# RESPONSES TO FDEP REQUEST FOR ADDITIONAL INFORMATION (RAI) OF JUNE 5, 2014.

SWWRF – Biosolids Improvement  
Project

**B&V PROJECT NO. 179508**

City of St. Petersburg

### ATTACHMENT A – COOLING TOWER CUT SHEET, PROCESS FLOW, AND REVISED SITE LAYOUT

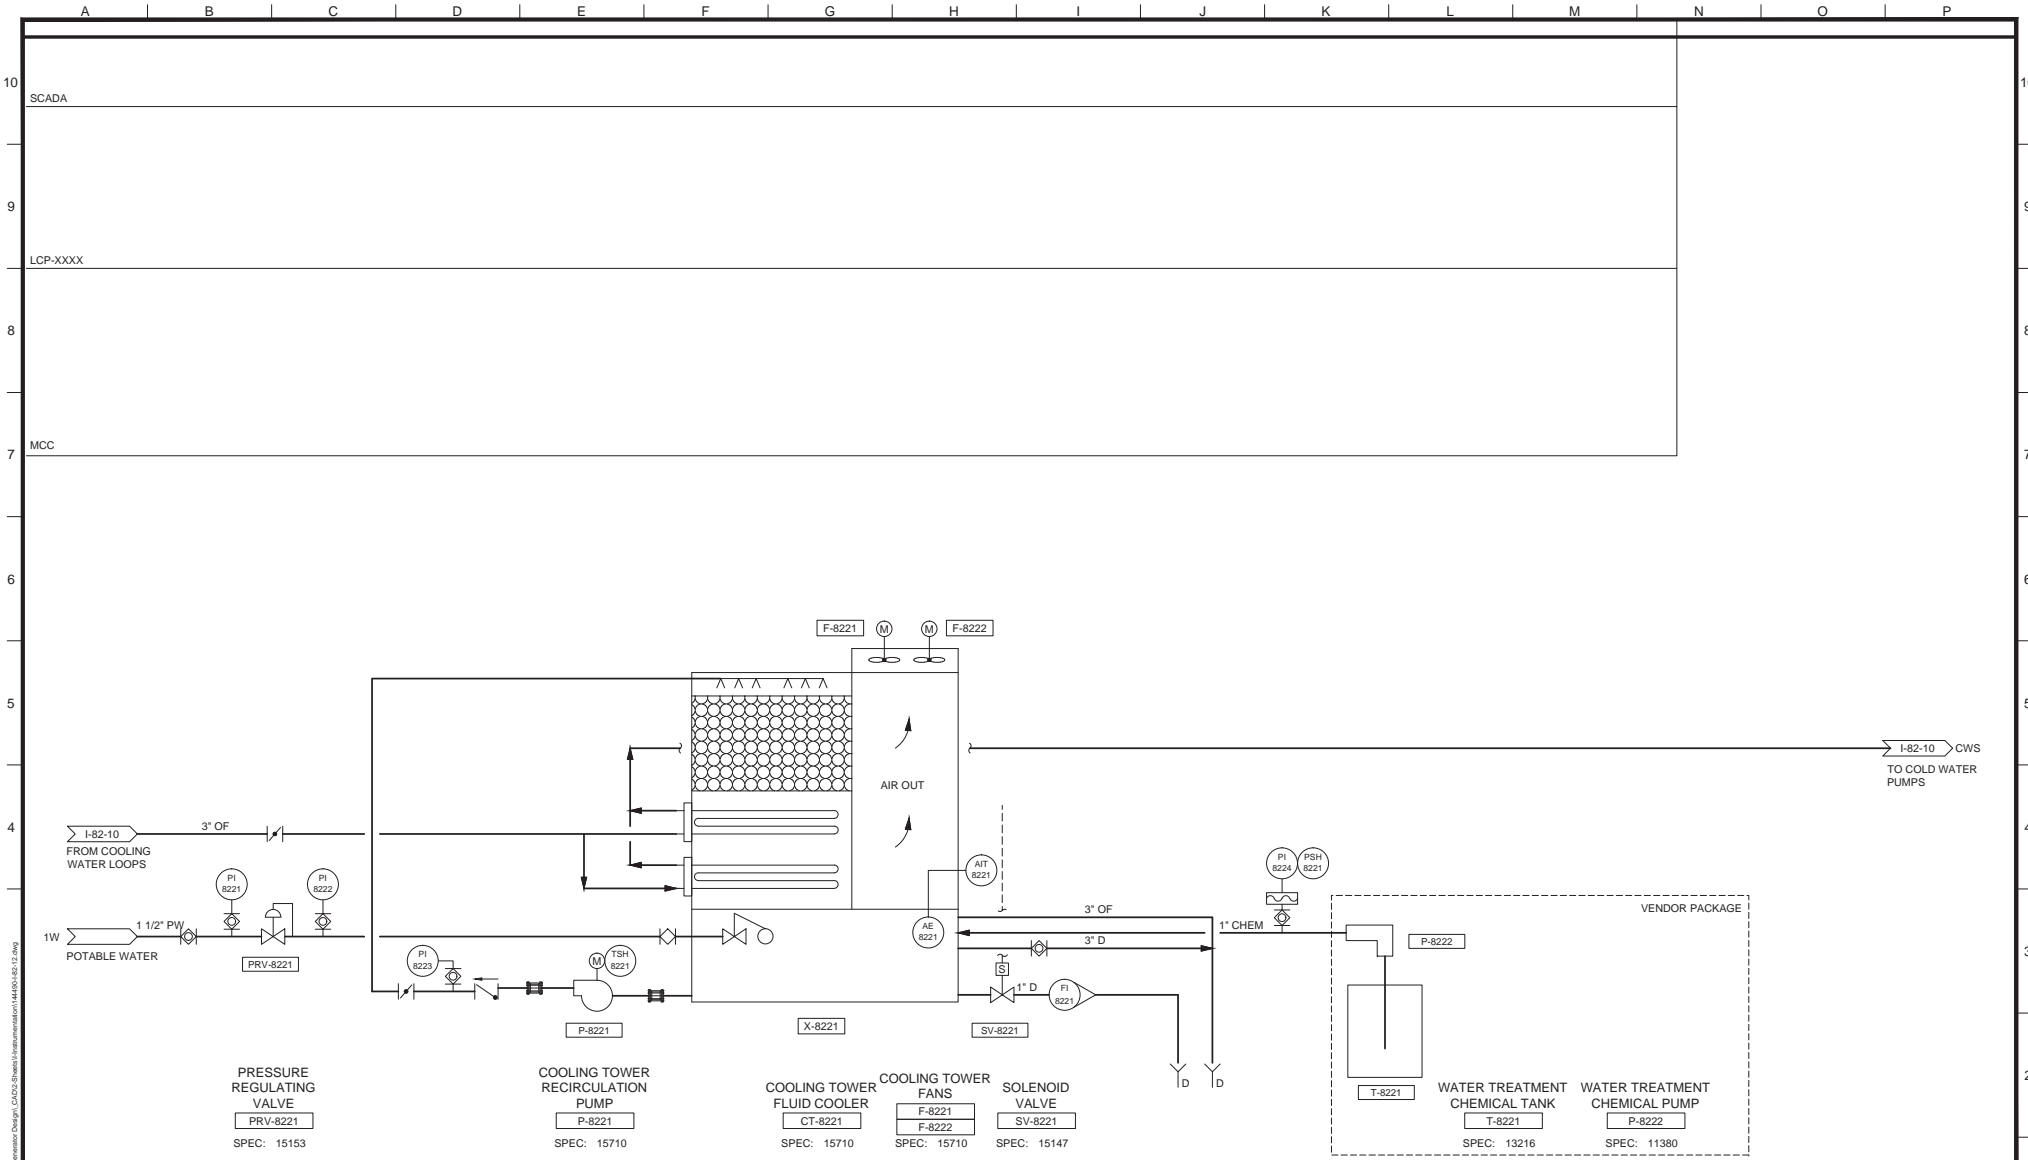
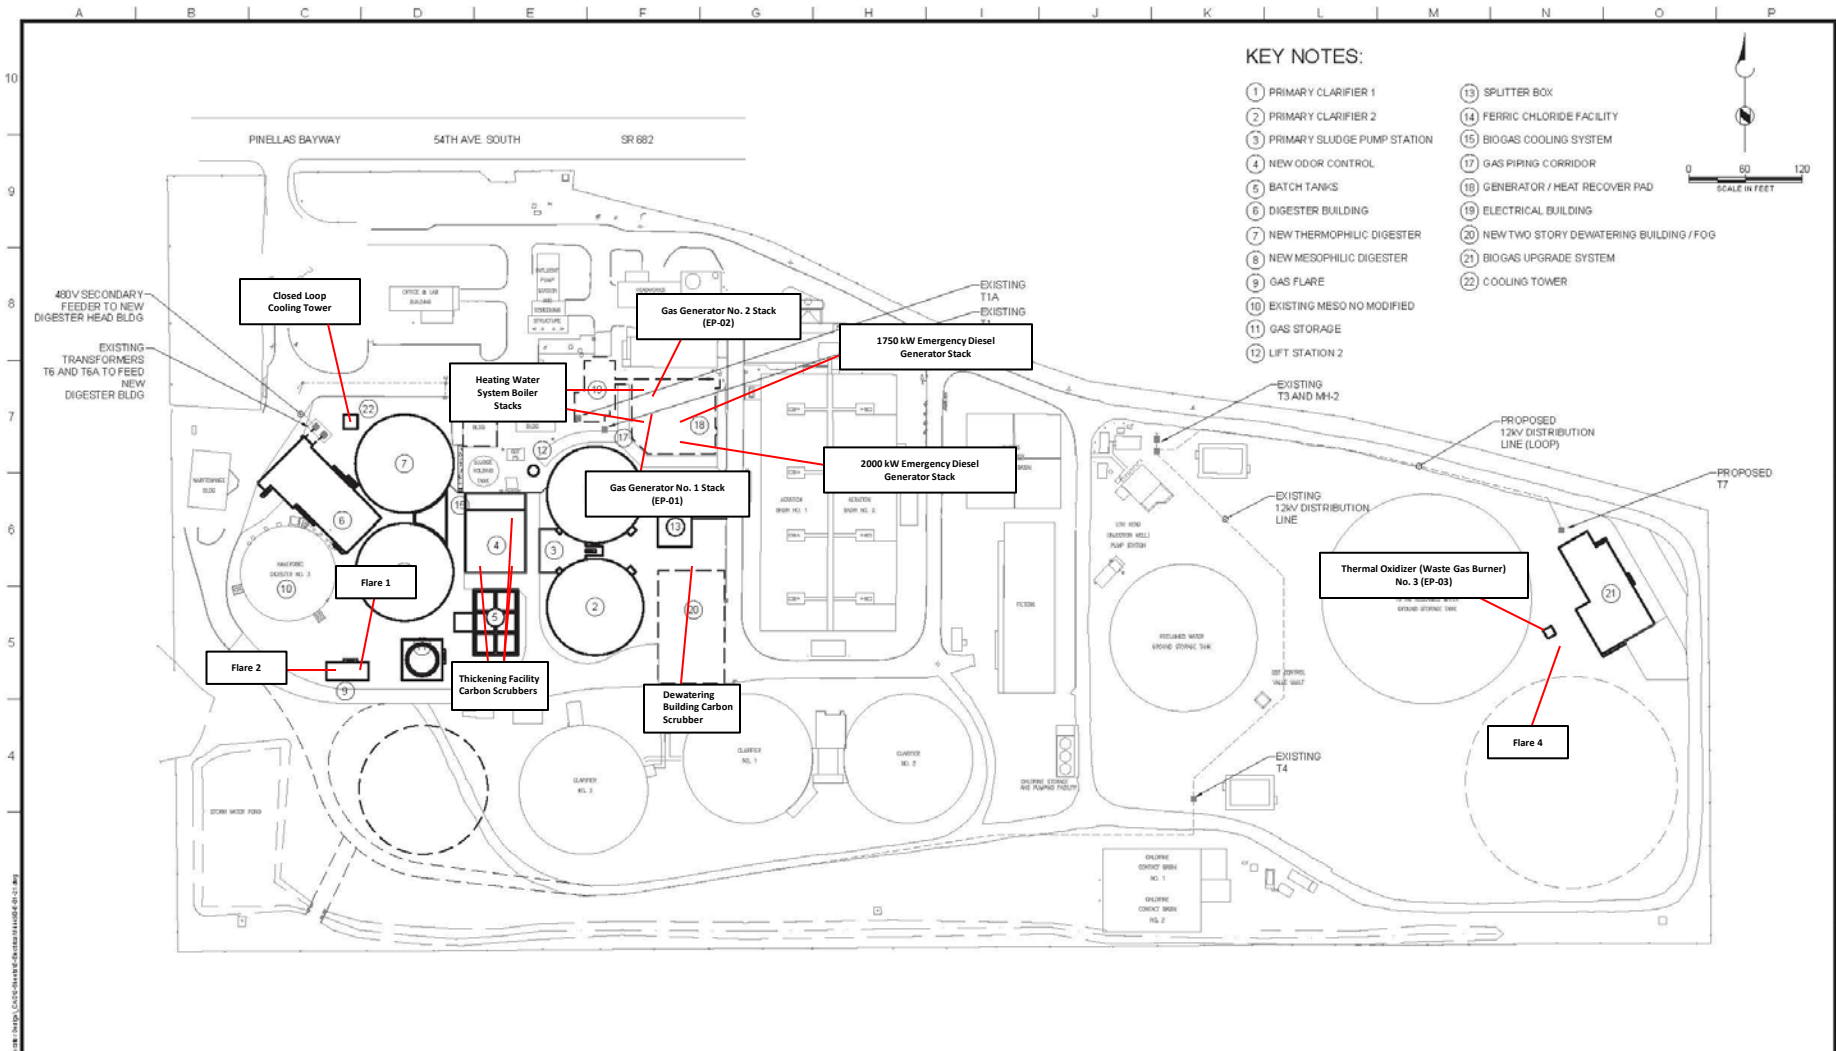
*Title V Major Source Applicability:* In determining if the facility is a Title V major source, the application does not include all of the proposed emission units at the facility as well as the facility-wide hazardous air pollutants (HAP). Please identify each regulated pollutant which the applicant knows or has reason to believe the facility emits or has the potential to emit in a major amount. Major source thresholds are as follows:

Please note that the design of the Biosolids Improvement Project (BIP) now includes a cooling tower to facilitate requisite cooling of the mesophilic digesters and the raw digester gas prior to entering the Biogas Upgrading System (BUS). Relevant information pertaining to the cooling tower, including the cooling tower's location as depicted in an updated site layout, is provided in Attachment A. This cooling tower was not included in the original air construction permit application; however, its particulate emissions are now accounted for in this submittal. Additionally, the cooling tower qualifies for an exemption from the requirement to obtain an air construction permit under the conditions of Rule 62-212.300(3)(b)(1), F.A.C. In order to be considered exempt, the following conditions of Rule 62-212.300(3)(b)(1), F.A.C. must be met (the demonstration of the satisfaction of these conditions are also provided below);

## ATTACHMENT E – BUS PROCESS FLOW DIAGRAM

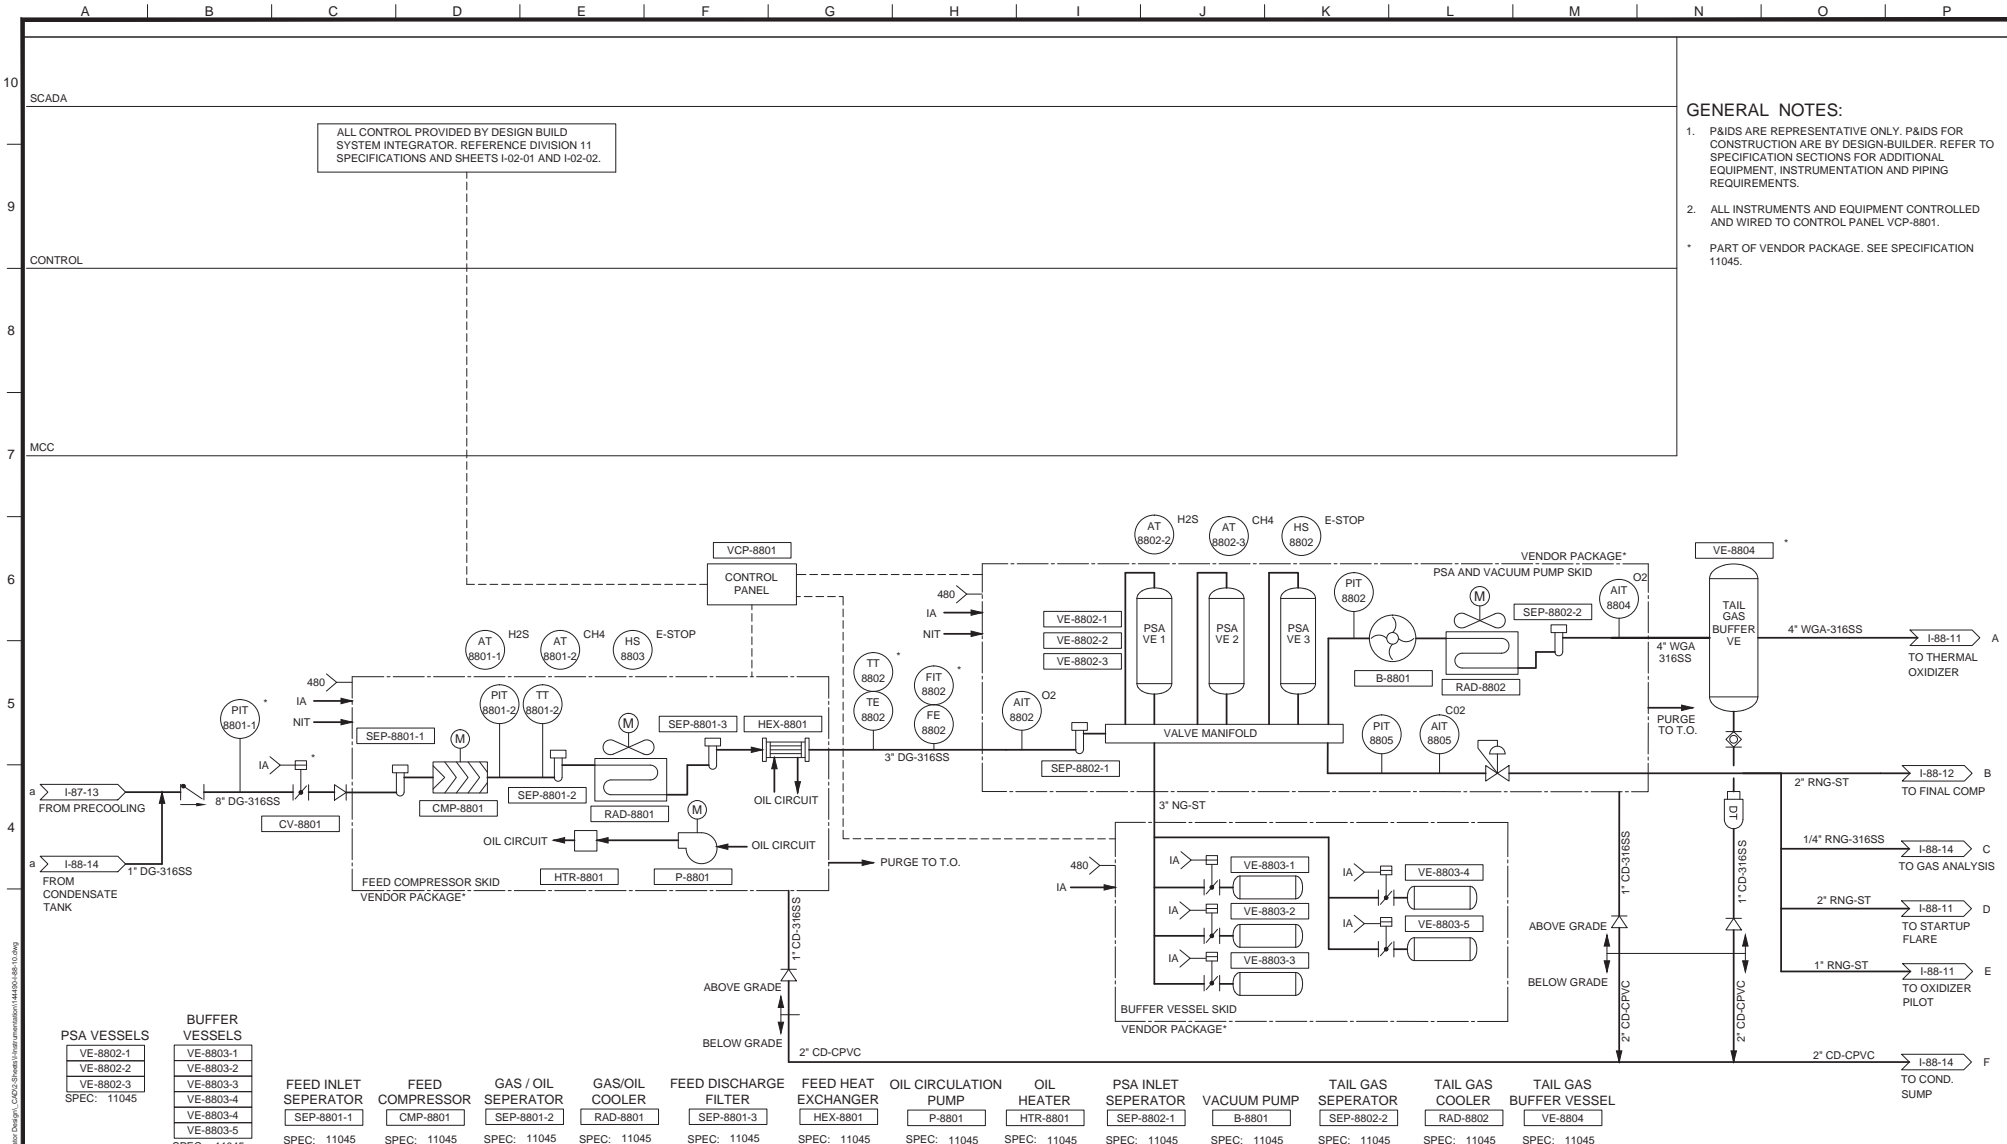
*Digester Gas Cleanup Process:* Based on the application, this project will clean the digester gas to meet natural gas standards. Please provide a detailed description and process flow diagram of the digester gas cleaning process, including:

a. Please describe the contaminants that are expected to be in the digester gas after it is released from the anaerobic digesters and how the processing removes these contaminants, specifically focusing on hydrogen chloride (HCl), formaldehyde, hydrogen sulfide (H<sub>2</sub>S), metals, and precursor elements such as, chlorine, fluorine, nitrogen, and sulfur.

b. The equipment used in the digester gas cleanup system, the control efficiencies of any equipment used and any other supporting information including vendor guarantees.

c. Please explain the process and identify what the digester gas will be composed of prior to being combusted in the flares and engines.

A process flow diagram depicting the BUS process can be found in Attachment E.
